COUNCIL ASSESSMENT REPORT

Panel Reference	PPS-2017SWC049
DA Number	DA 1331/2017/JPZ
LGA	The Hills Shire
Proposed Development	Staged concept masterplan to establish a revised heritage curtilage and Indicative Layout Plan to inform the eventual development of the site for residential flat buildings, mixed use/ shop top housing, multi dwelling housing, subdivision and dwelling houses
Street Address	Lot 1 DP 1235252, 10-32 Terry Road, BOX HILL
Applicant/Owner	McCall Gardens Community Ltd C/- DFP Planning Pty Ltd
Consultant/s	DFP Planning Consultants Hanna Newman Associates Pty Ltd Burton & Field McFadyen Architects Indesco Consulting Engineers SILK Consulting Landscape Architects AECOM WSP Parsons Brinckerhoff Ramboll Environ Australia Pty Ltd Anderson Environmental Pty Ltd Thompson Stanbury Associates
Date of DA lodgement	7 March 2017
Number of Submissions	None
Recommendation	Approval subject to conditions
Regional Development Criteria (Schedule 7 of the SEPP (State and Regional Development) 2011	Staged concept masterplan (no physical works) but relating to eventual development with a Capital Investment Value of more than \$30,000,000.00

List all documents submitted with this report

1 : 100	0	1m	2m	3m	5m
Checked: MB	Sheet: A3	Job No: 702	Phase: MP	Dwg No: A124	Rev: B

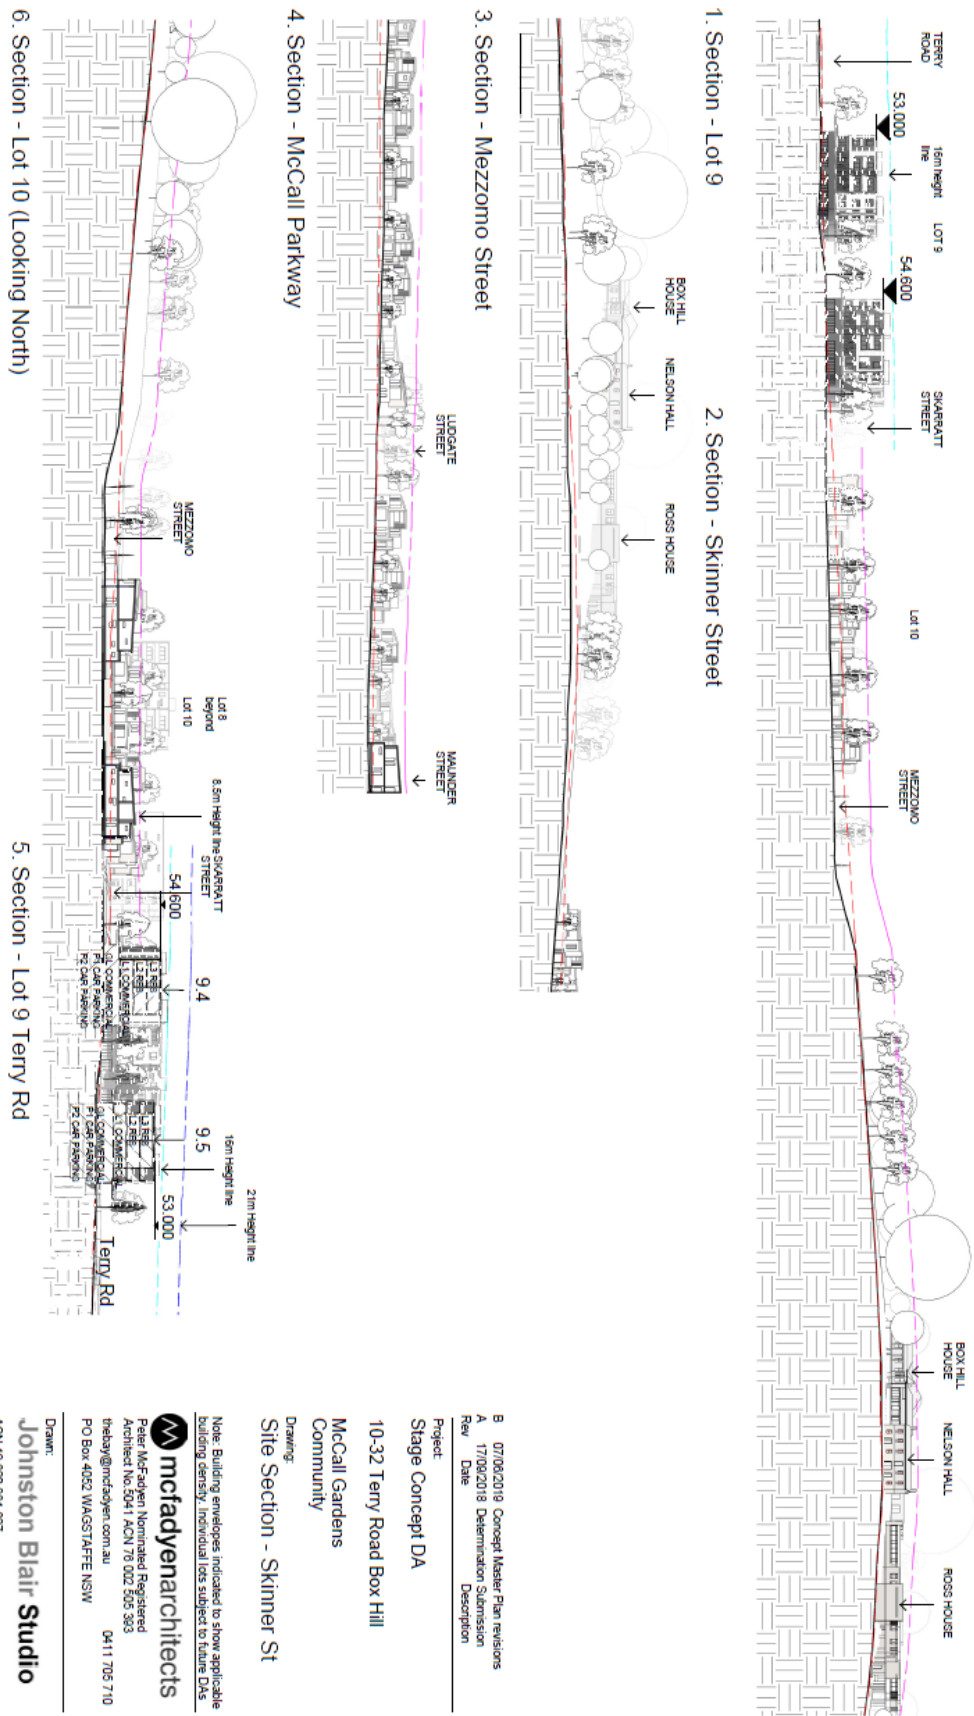
For example, Drawing A124 illustrates a number of section drawings. The section at the top of the page is numbered Section 1 and Section 2 which is unclear in itself. The RL associated with the section shows an RL of buildings on Lot 9 as 53.00 and 54.600 respectively. This does not include the lift overrun and does not include the natural ground level of finished ground level. Without this detail, Council is unable to determine the actual height of buildings and associated RL.
